# Product Change Notification

## 109288 - 00

**Change Notification #:** 109288 - 00  
**Change Title:** DG35EC, PCN 109288-00, Product Design, Component Change  
**Date of Publication:** March 18, 2009

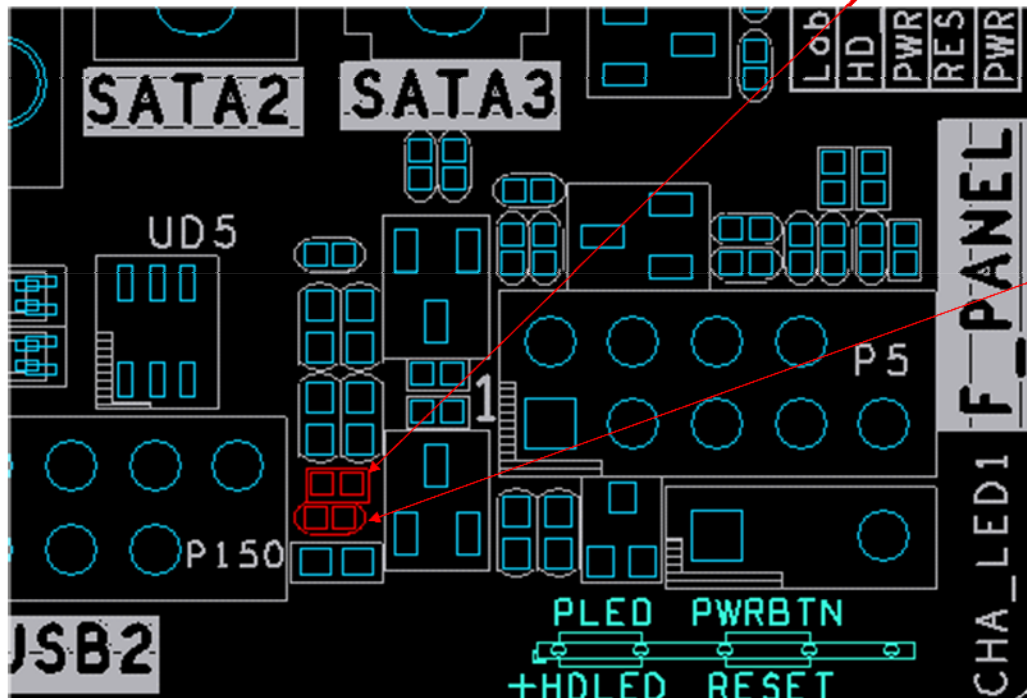
The 0.1uF capacitor at location SC68 has been changed from +/- 20% to +/-10% to enhance the board design and Real-time clock margins.

SC68, change from  
0.1uF +/-20% to +/-10%

SR16, no  
change
